**SUBJECT: SOUTH TEXAS PROJECT, UNITS 1 AND 2 - REQUEST FOR EXEMPTION TO EXCLUDE CERTAIN COMPONENTS FROM THE SCOPE OF SPECIAL TREATMENT REQUIREMENTS REQUIRED BY REGULATIONS; REQUEST FOR ADDITIONAL INFORMATION (TAC NOS. MA6057 AND MA6058)**

**SOUTH TEXAS PROJECT  
REQUEST FOR EXEMPTIONS TO EXCLUDE CERTAIN COMPONENTS FROM THE  
SCOPE OF SPECIAL TREATMENT REQUIREMENTS  
REQUEST FOR ADDITIONAL INFORMATION**

### REQUEST FOR INFORMATION TO SUPPORT INITIATIVES TO INCORPORATE RISK-INFORMED INSIGHTS INTO 10 CFR PART 50 REGULATIONS

**Figure 1: Diagram of Categorization and Treatment**

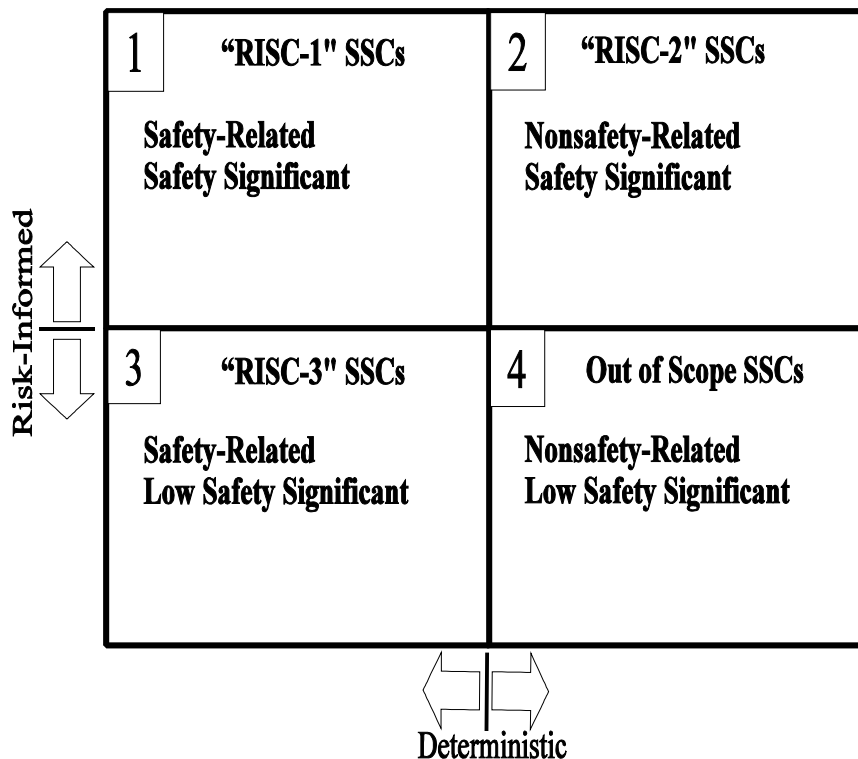
1. In SECY-99-256, "Rulemaking Plan for Risk-Informing Special Treatment Requirements," the NRC staff describes a scheme for categorizing SSCs according to their safety significance and status under the deterministic safety-related regime. This scheme divides SSCs into 4 bins. (See Figure 1.) Risk-informed safety class 1, or RISC-1 SSCs are presently safety-related and are determined to be safety significant by a risk-informed categorization process. RISC-2 SSCs are not presently safety-related, but have been determined to be safety significant by a risk-informed categorization process. RISC-3 SSCs are presently safety-related, but have been found to be of low safety significance by a risk-informed categorization process. Remaining SSCs are expected to be out of the scope of special treatment requirements, though other regulatory controls may still apply.

In an effort to equate current Risk-informed Rulemaking efforts with your exemption request, please describe how the STP risk categorizations compare to these classifications.
